HYUNDAI

Technical Service Bulletin

GROUP CAMPAIGN	NUMBER 22-01-023H-2
DATE NOVEMBER 2022	MODEL(S) APPLICABLE VEHICLES BELOW

SUBJECT: DTC P1326 - ENGINE BEARING INSPECTION / ENGINE REPLACEMENT (SERVICE CAMPAIGN T6G)

For 11-12MY Sonata Hybrid (YF HEV):

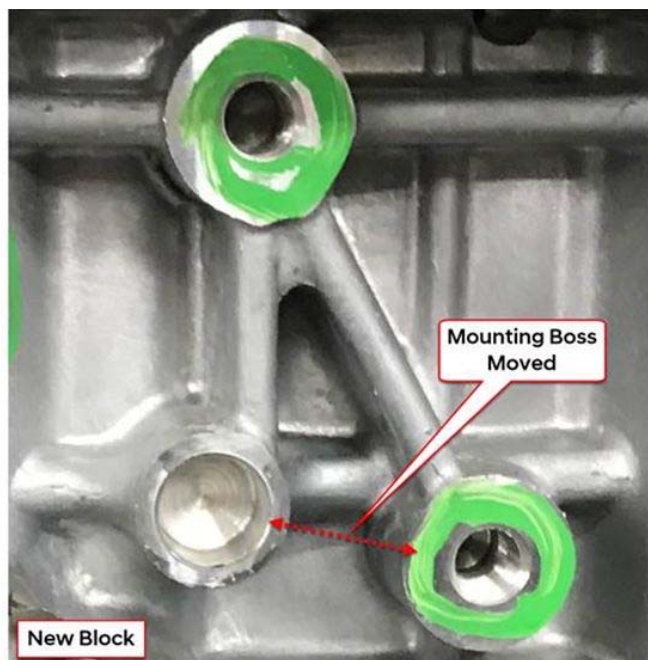
When installing a new engine, the drive plate bolts must be replaced with P/N 23231-25200.

- ❖ Due to changes to the crankshaft design, the existing bolts are ~2mm too long and will result in improperly fastened drive plate if reused.
- ❖ The 13-15MY version drive plate bolts (P/N 23231-25200) are correct length for the new engine and will provide proper fastening during engine installation.
